**The Highland Council**  
**Skye, Ross and Cromarty Area Committee**  
**30 April 2014**

**Proposed 20mph Speed Limit and Traffic Calming Features in Muir of Ord**

**Report by Director Community Services**

**PLAN NO.** RC/MOSL20TC/14/001A

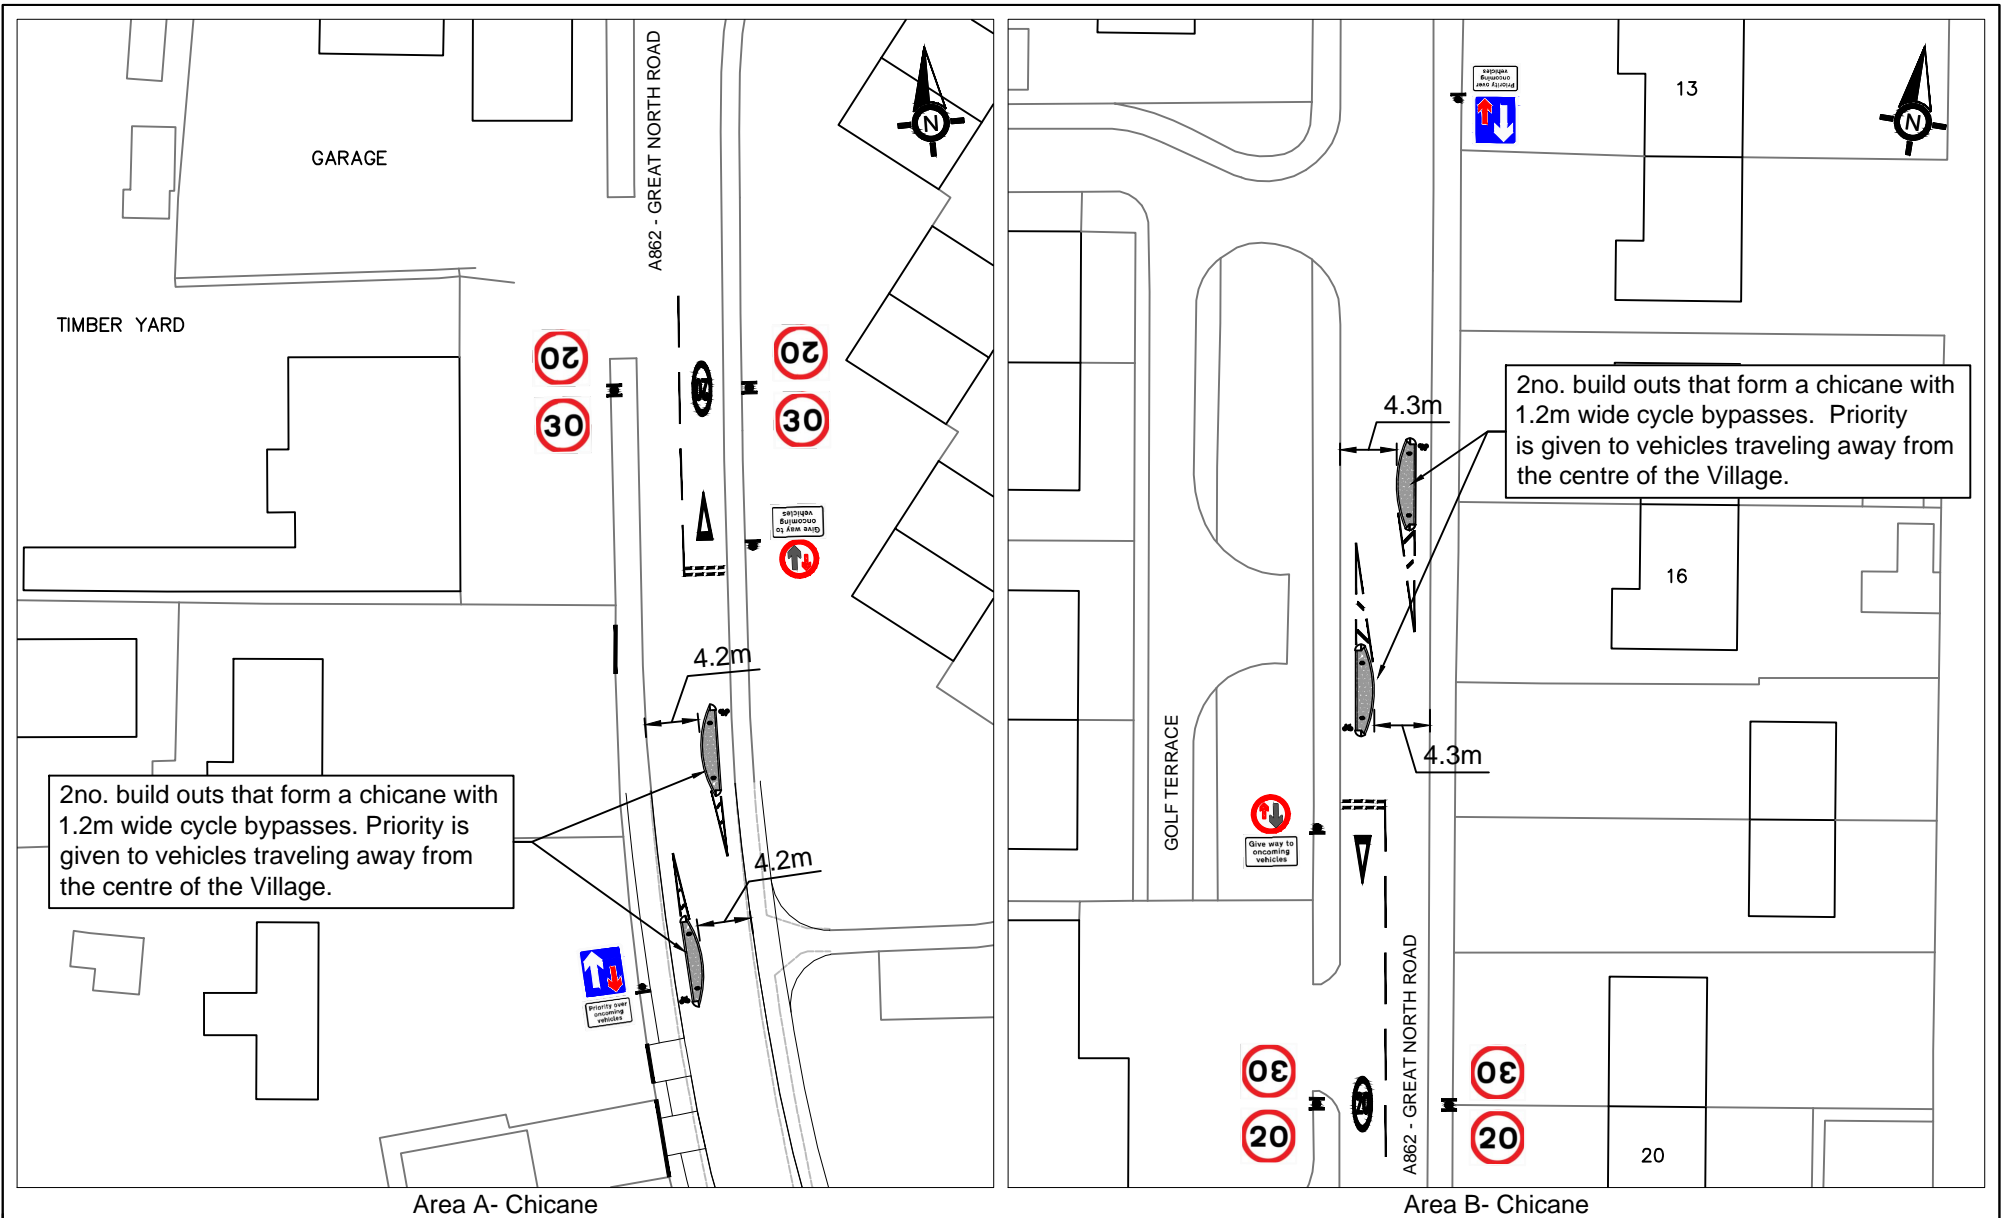
- 5.1 There has been 1no. objection to the proposal as a whole and this was on the grounds that:
- The traffic calming features do not extend far enough from the Village centre.

- The proposal would have a negative impact on driver behaviour within the Village. Particularly, on the roads immediately out with the proposed new speed limit as drivers would be frustrated and speed up to make up time.

- No speed checks will be carried out (except close to the Primary School) in order to enforce the new 20mph speed limit.
  - The proposal will not improve safety in the Village centre as the volume of traffic, parked cars and road junction does not generally allow for vehicles to travel at 30mph.

We wish to declare our objections to the proposed traffic calming measures on the Great North Road, PLAN NO: RC/MOST 20TC/14/001. The exit from is at present difficult enough, without the added hazard of facing oncoming large vehicles, trying to manoeuvre through a chicane in our direction. Having lived here over 60 years, we are not aware of any accidents on this

- Existing vehicle speeds are above the recommended threshold for introducing a 20mph speed limit through signing alone.
  - The chicanes have been located immediately within the proposed new speed limit to ensure that vehicles reduce their speed appropriately.

- If we were to extend the 20mph speed limit and/ or include more traffic calming features on this road we feel that this may indeed have a negative impact on driver behaviour.

- The proposal aims to balance the reduced vehicle speeds at the centre of the Village and minimise traffic delays.
- The proposed new speed limit will be largely self-enforcing, however, speed counts will be undertaken once the scheme is complete in order to monitor its effectiveness.
- The proposal will see vehicle speeds reduced along many pedestrian and cycle routes in the Village centre which will improve road safety and make the environment more pleasant for pedestrians and cyclists.
- Reduced speed limit will allow more time for pedestrians to cross the road and this will be of particular benefit at the junctions of the A862 Great North Road / Seaforth Road / A832 Black Isle Road and the A862 Great North Road / A832 West Road.

PLAN NO. RC/MOTC/14/002

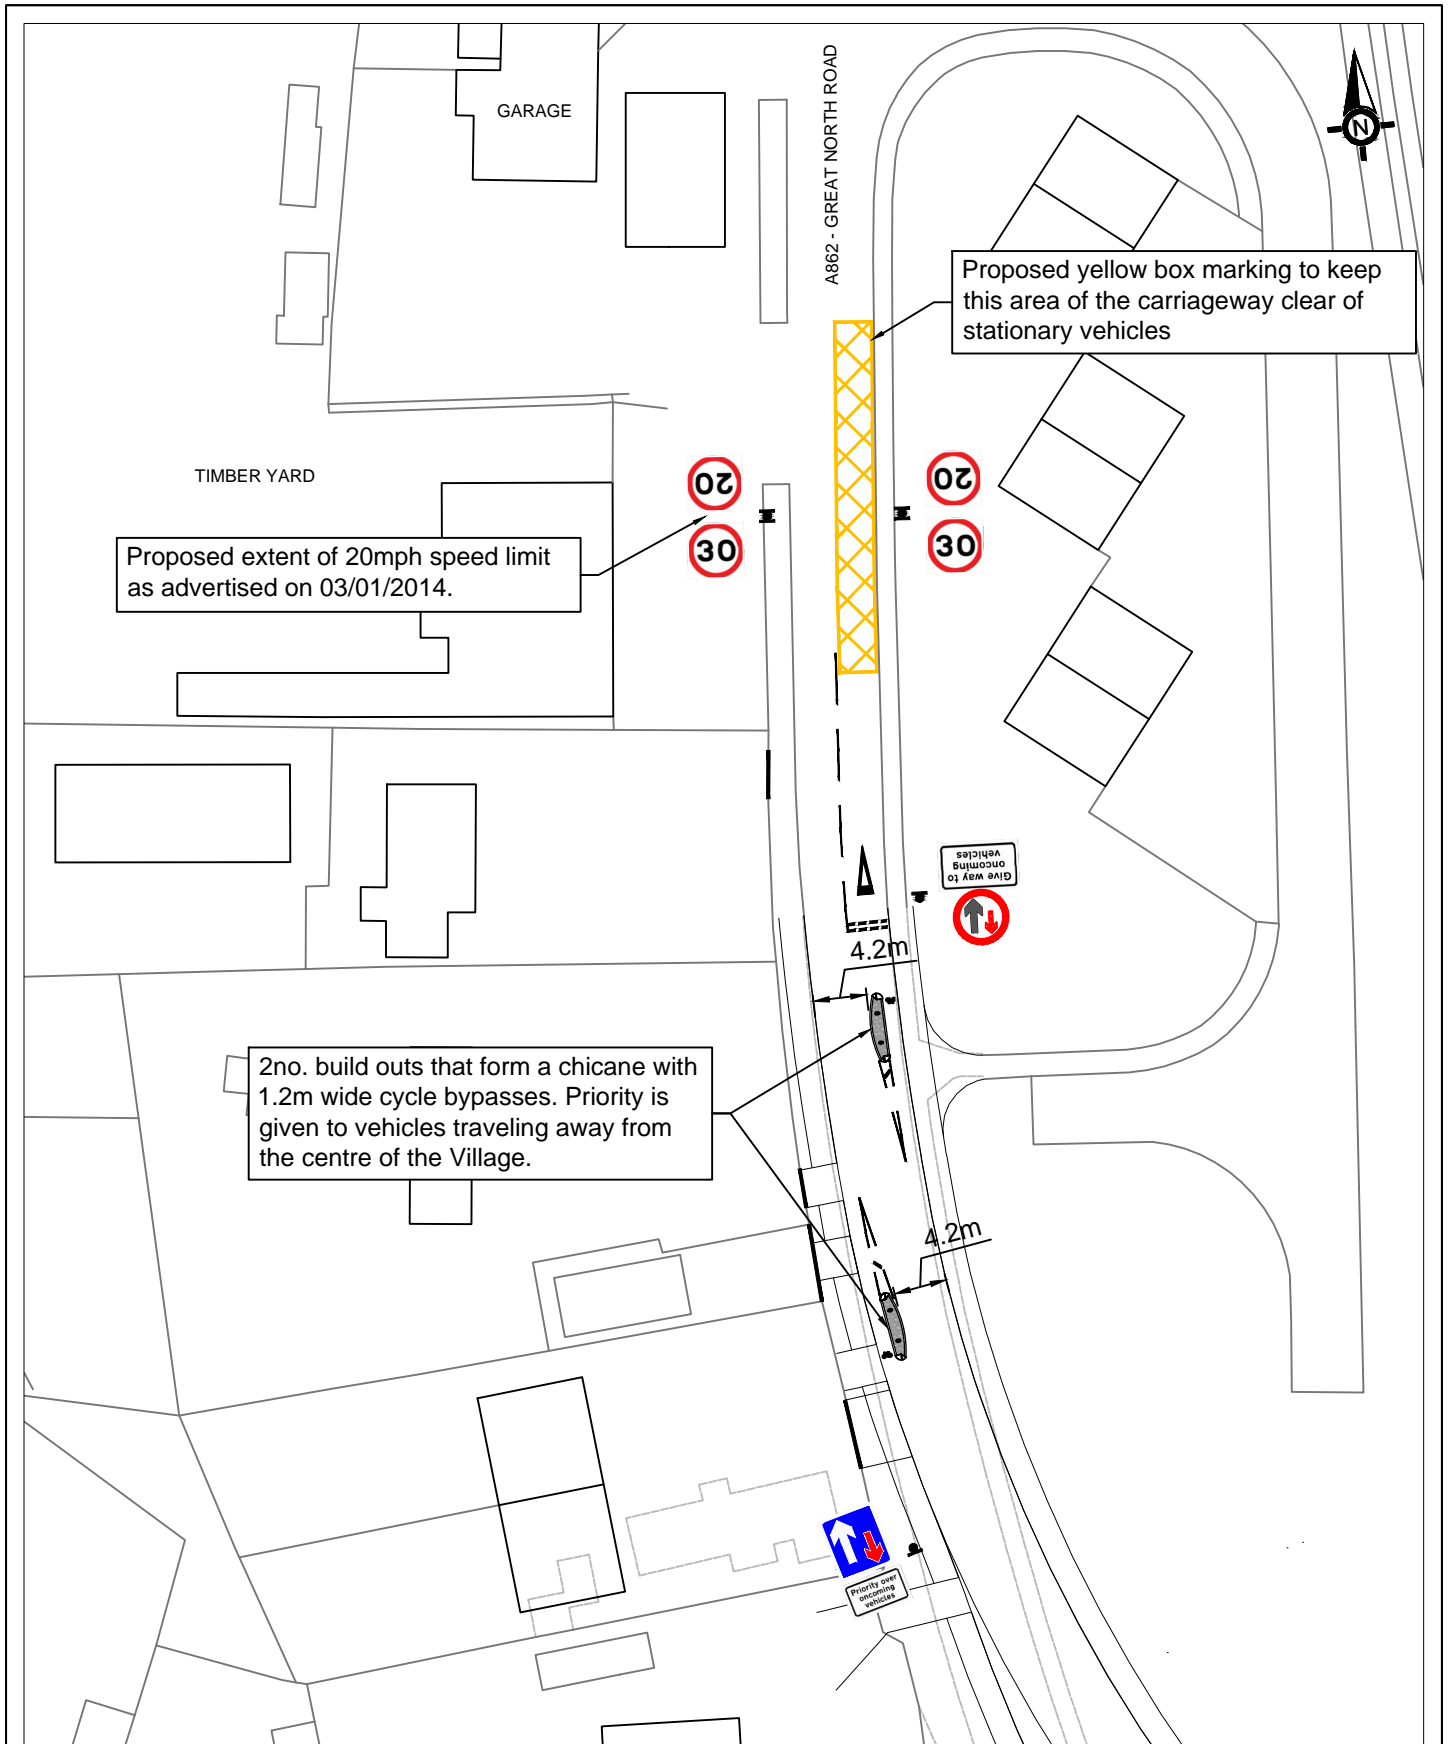
6.3 Two of the objections came from owners of businesses near to the proposed chicane and they raised concerns that the design of the chicane would make it difficult for lorries to make deliveries to their premises.

1. A chicane so close to the west road junction in my view is dangerous, also "Ord Wood Products" has 40 foot lorries delivering almost daily and we have 40 foot tankers delivering fuel once a week plus our food deliveries and our petrol station/shop traffic this Chicane will make it dangerous for these to lorries manoeuvre.

I hereby wish to declare my strong objections to the proposed plan  
RC/MOST20TC/14/002

on the Great North Road (Dingwall side). My business involves large Timber Lorries delivering logs and sawn timber to the yard on a weekly basis. These Artic Lorries, are on average 60 feet long, carrying approximately 44 tons weight, some with attached trailers meaning they need more room to manouver into the Yard at a restricted angle. It would be impossible to get these vehicles through a Chicane, and be able to turn into the Yard

6.4 In response to these concerns, software was used to evaluate vehicle movements for their premises. This confirmed that the siting of the build outs would not restrict access, however, large vehicles travelling northbound would be unable to turn into their premises if there were oncoming vehicles waiting at the giveway line.

6.5 The design of this chicane was amended by moving the chicane slightly further south and introducing a yellow box marking. A plan showing the amended location and design of this chicane is contained in **Appendix 1C**.
